DEPARTMENT OF THE ARMY
NEW ORLEANS DISTRICT, CORPS OF ENGINEERS
P.O. BOX 60267
NEW ORLEANS, LOUISIANA 70160-0267

SUBJECT: MVN 2010-1041 WB
General Permit NOD-20

Receipt is acknowledged of your letter dated May 20, 2010, requesting authority to install HESCO Baskets being placed along sections of beach situated between Fourcheon and Grand Isle area in Lafourche/Jefferson Parishes to prevent oil encroachment into interior marshes that resulted from the BP Oil spill Deepwater Horizon.

**Proposed HESCO Basket Placement Area**

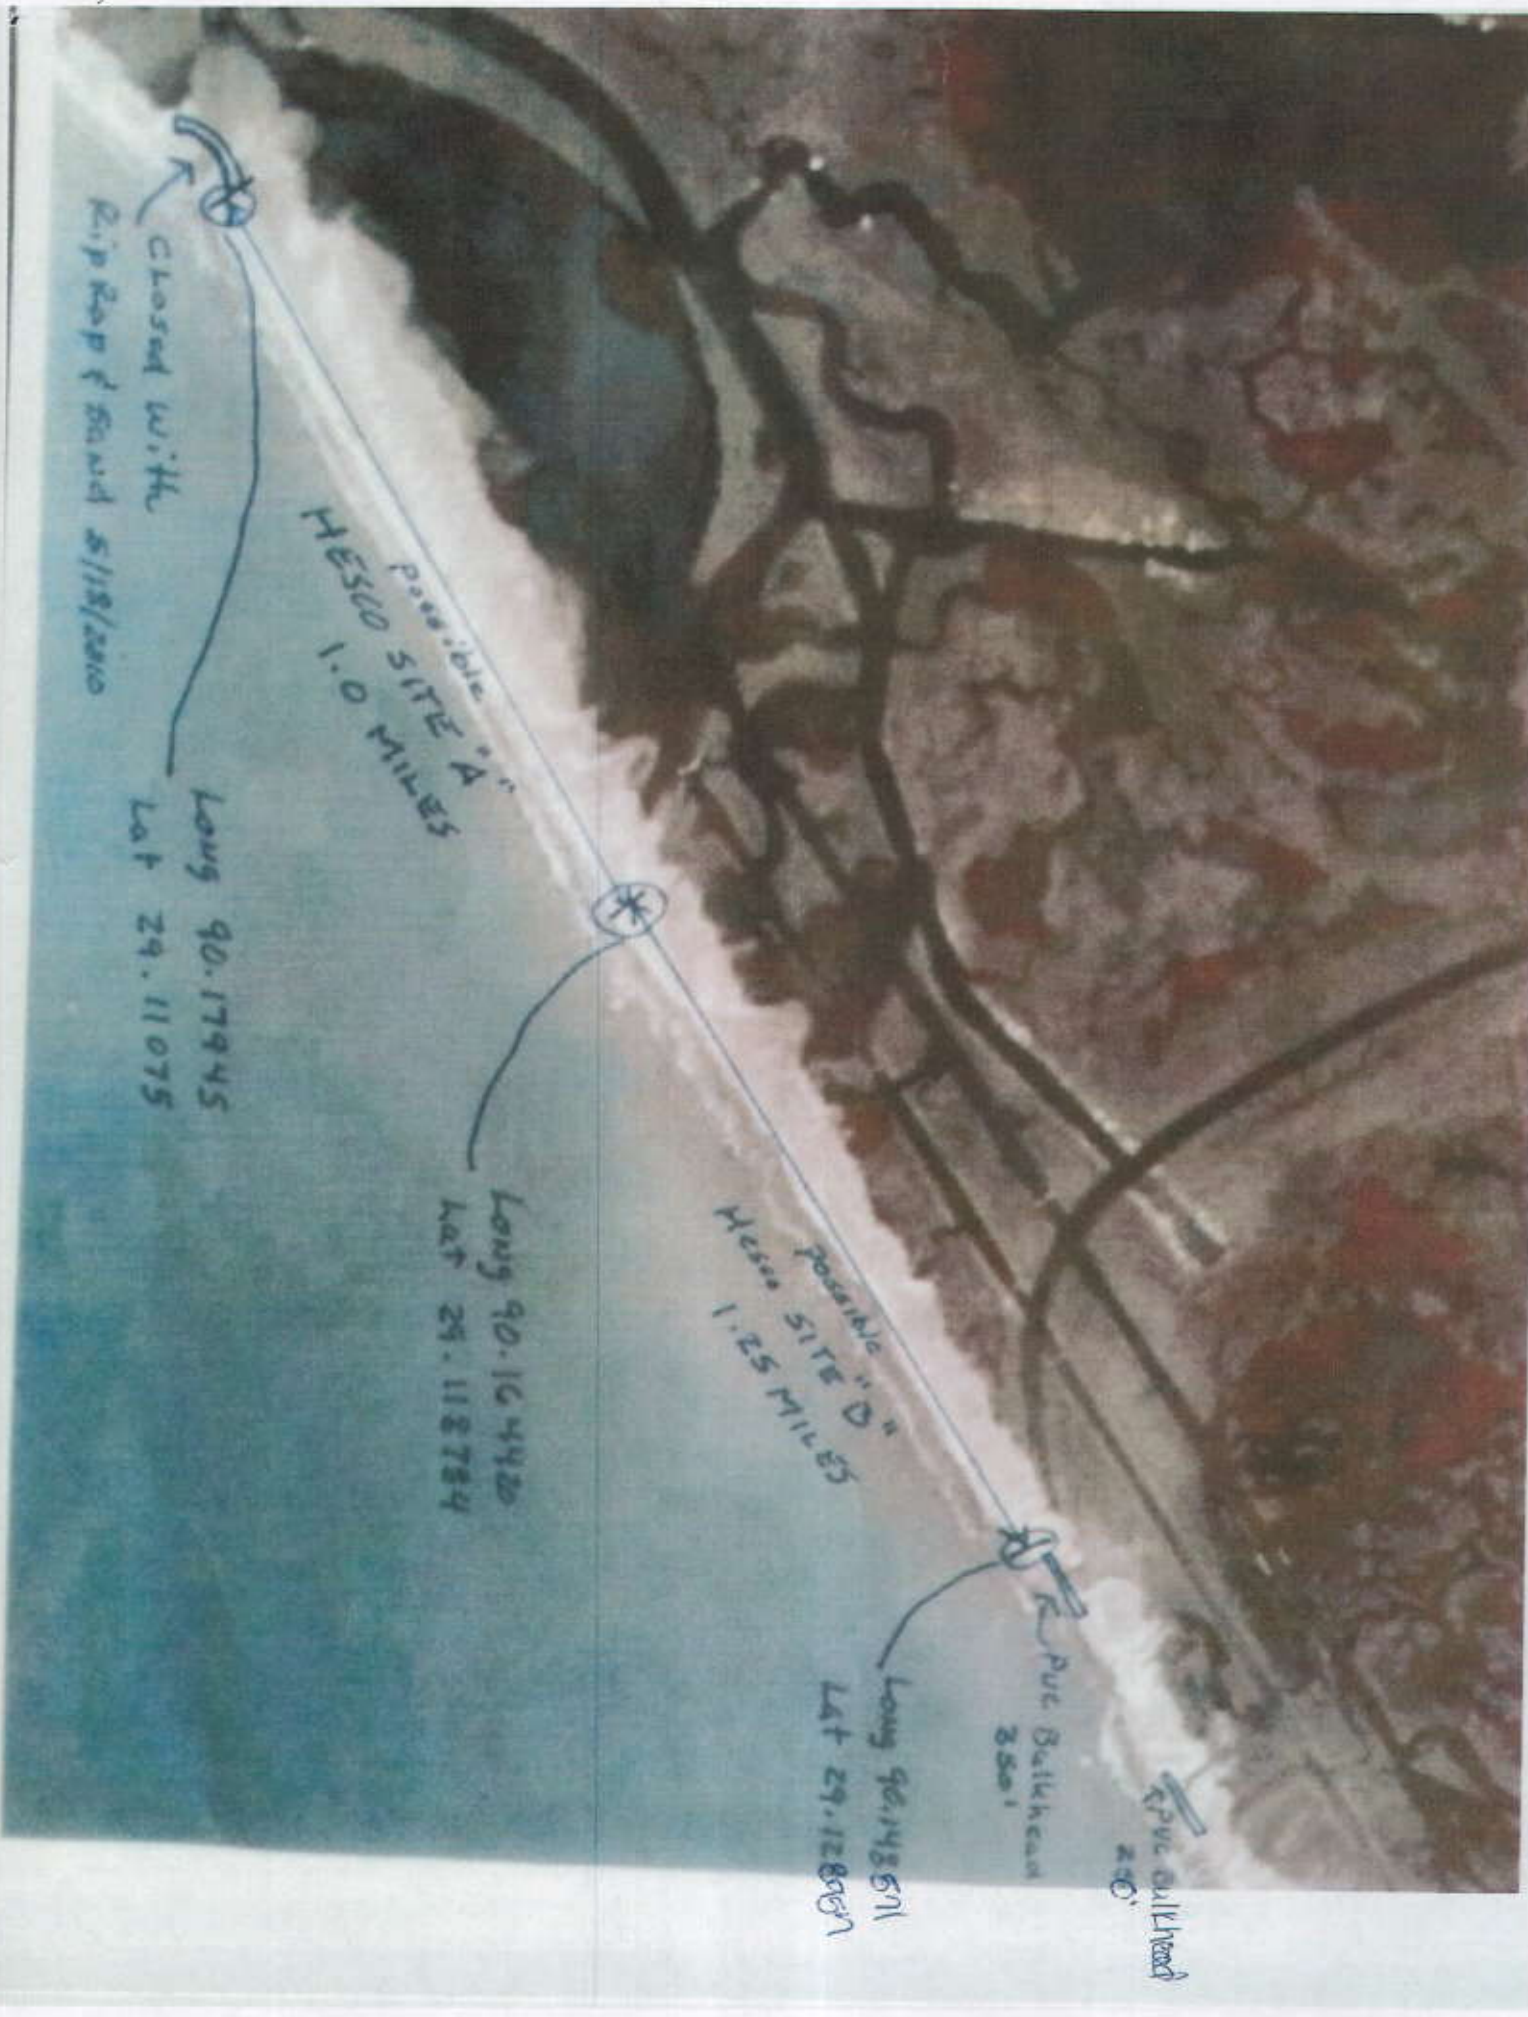
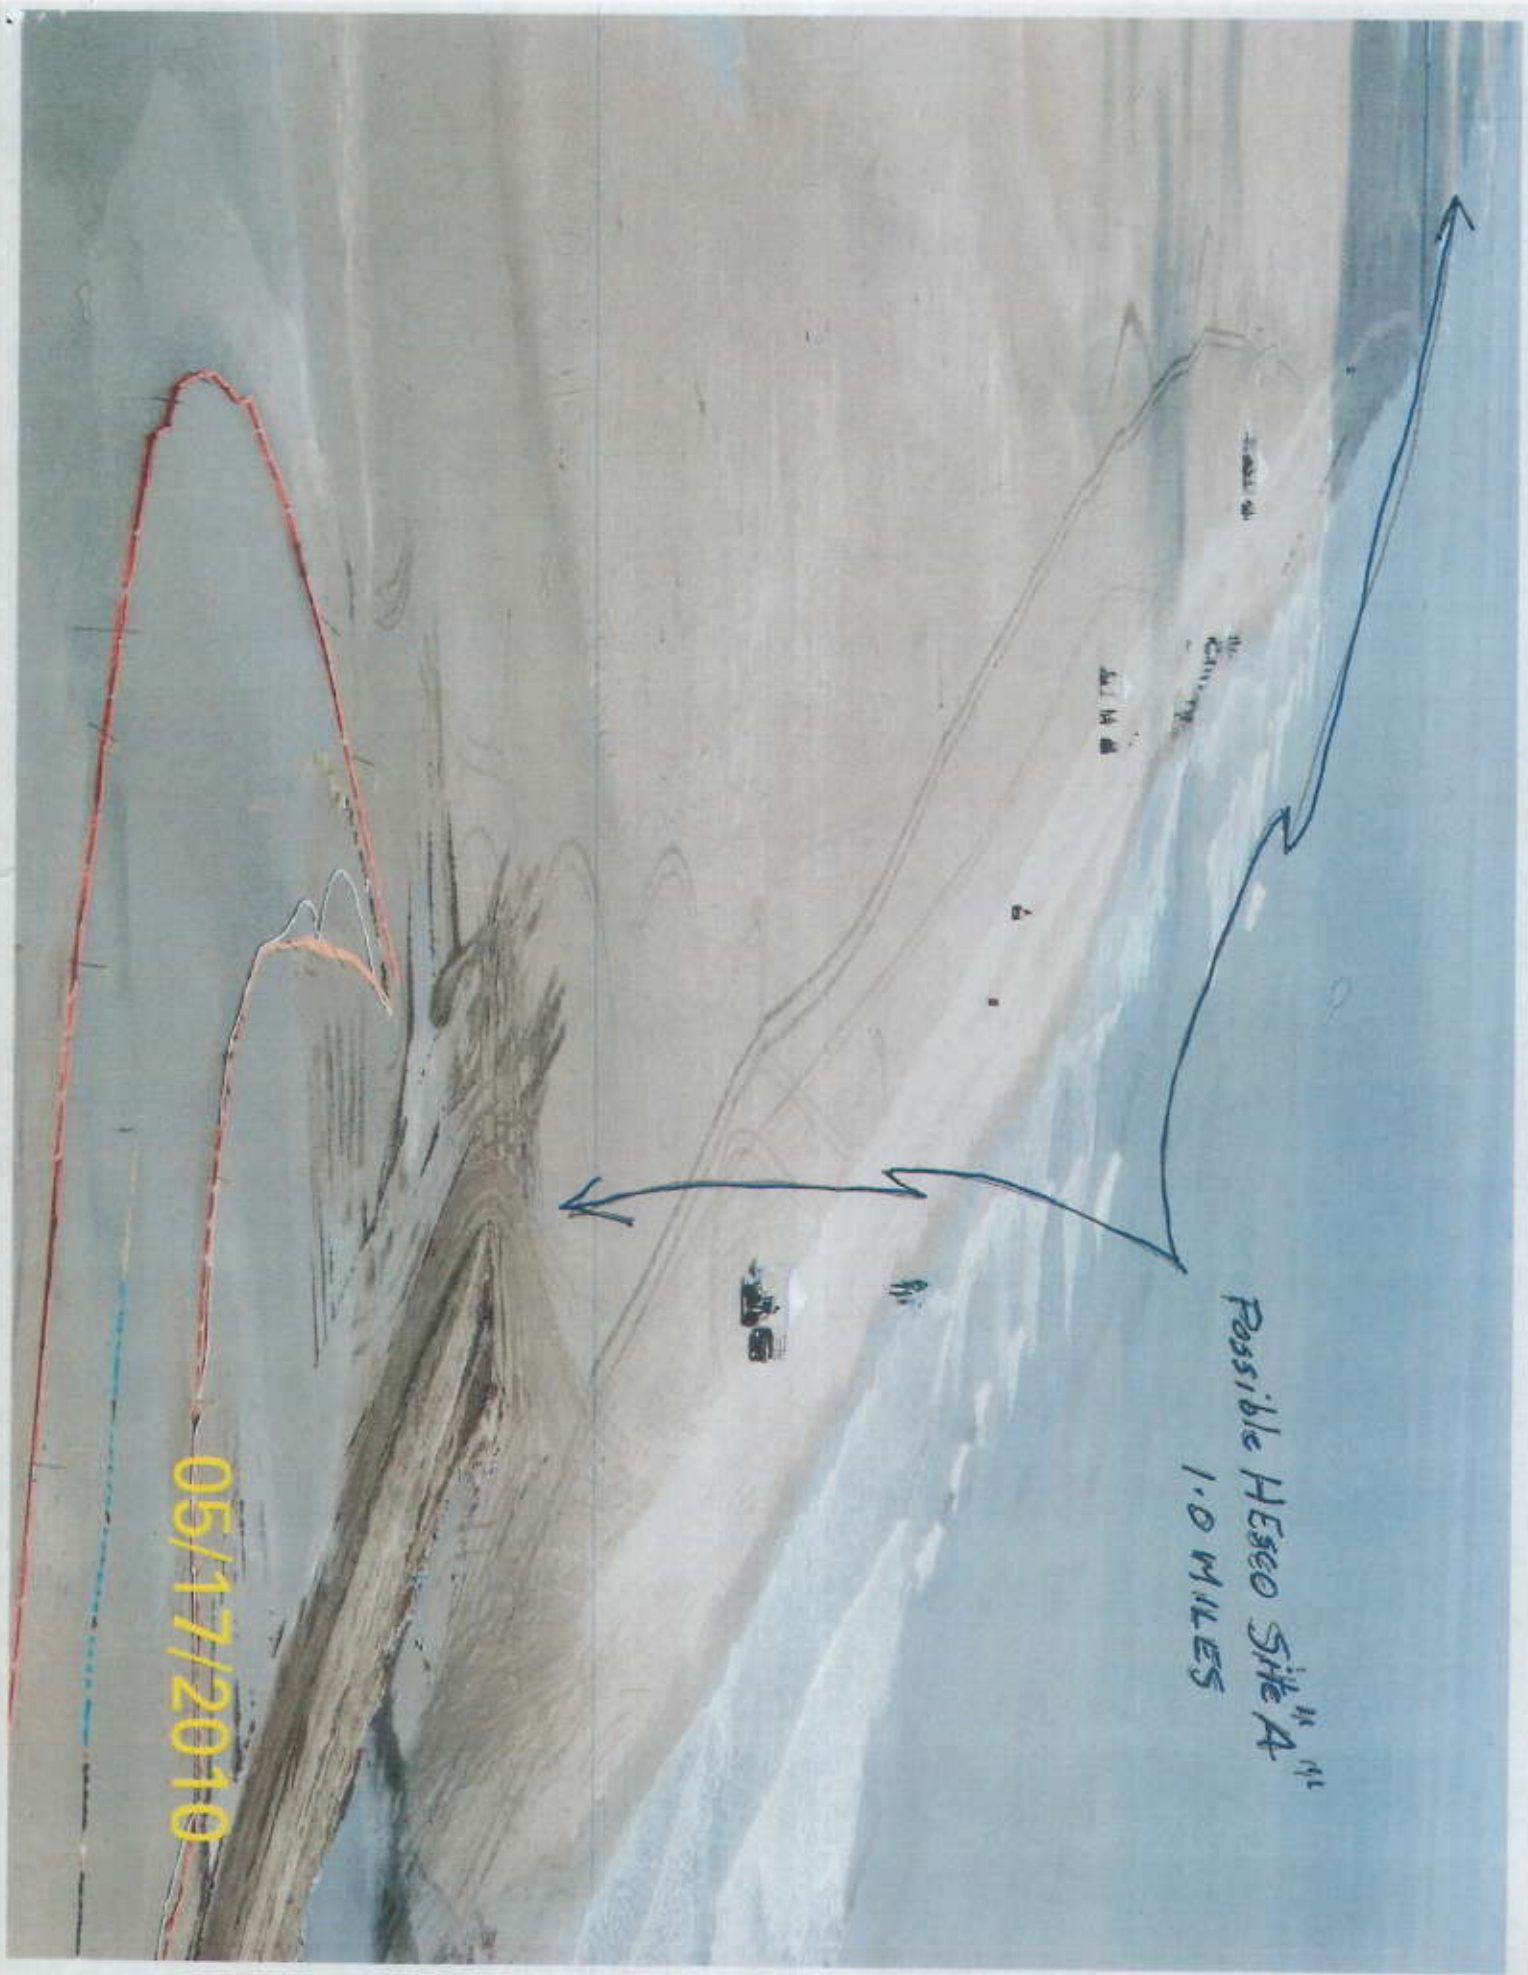
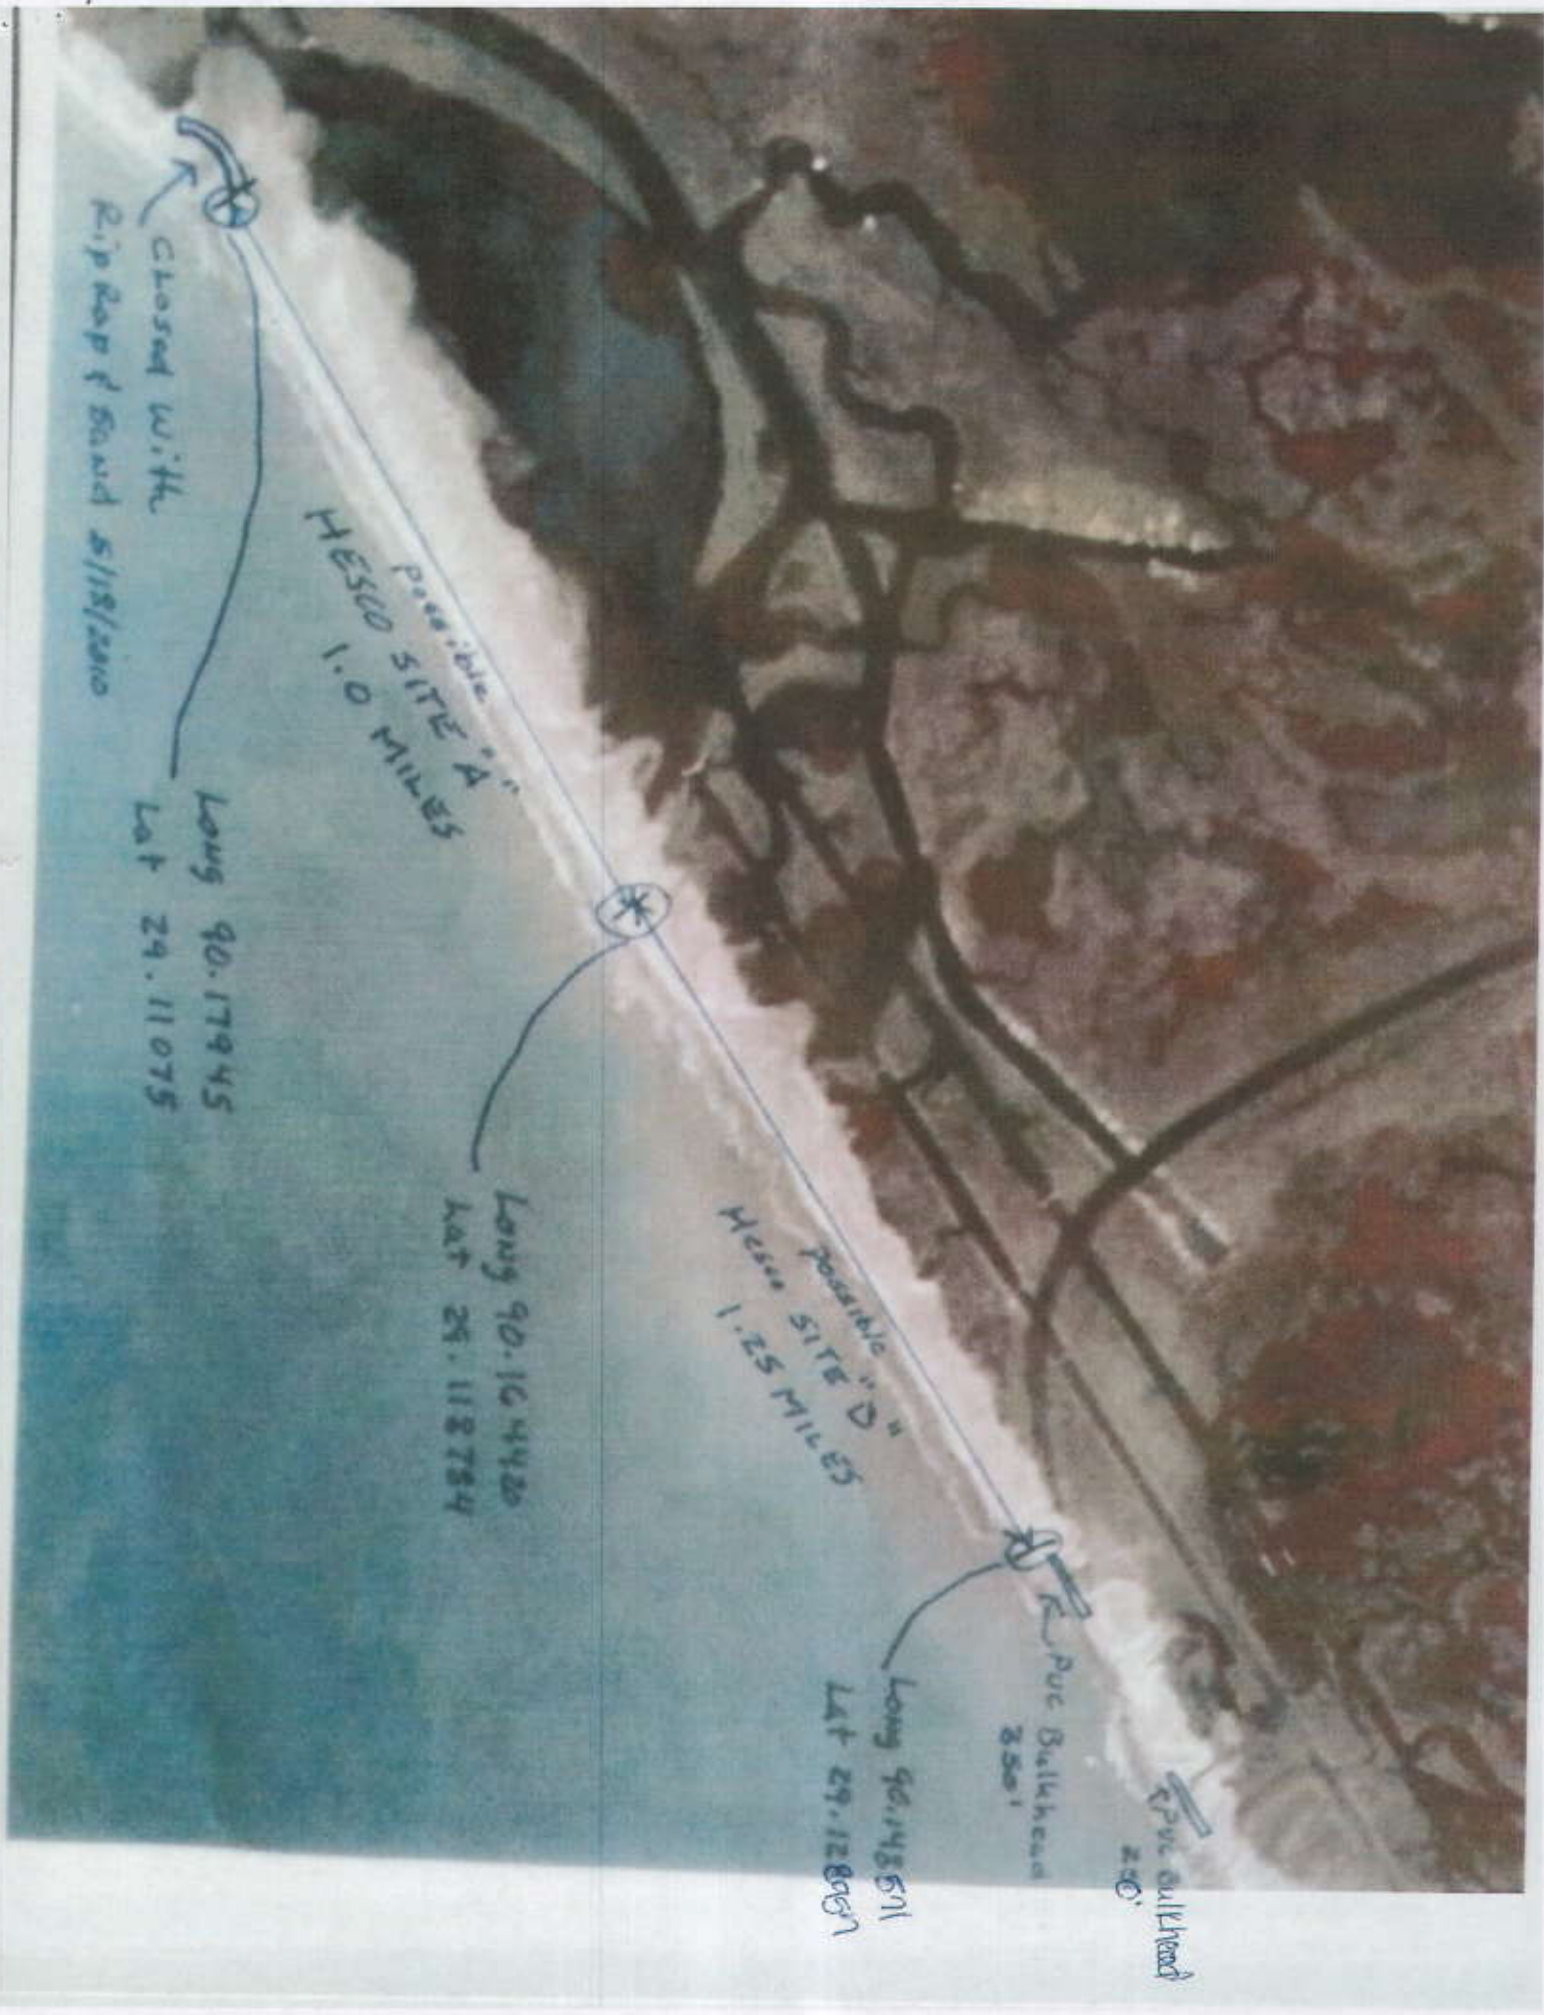
MVN Regulatory is in receipt of a new emergency response request from the State of Louisiana, Department of Natural Resources, on behalf of Lafourche Parish Government; which includes the installation of HESCO baskets being placed along sections of beach situated between Fourcheon and Grand Isle area in Lafourche/Jefferson Parishes. Preliminary information provided by DNR stipulated that these baskets will be placed according to the attached figures.

The Service is committed to the protection of Louisiana's wetlands from ongoing land loss and the added impact of the oil spill. We also remain committed to working closely with all agencies involved in spill response efforts to further explore alternatives and alternative features in order to reduce the current degree of risk and uncertainty associated with any oil spill response activities.

The sand utilized in this project shall be free of contamination and suitable for use in coastal restoration projects.
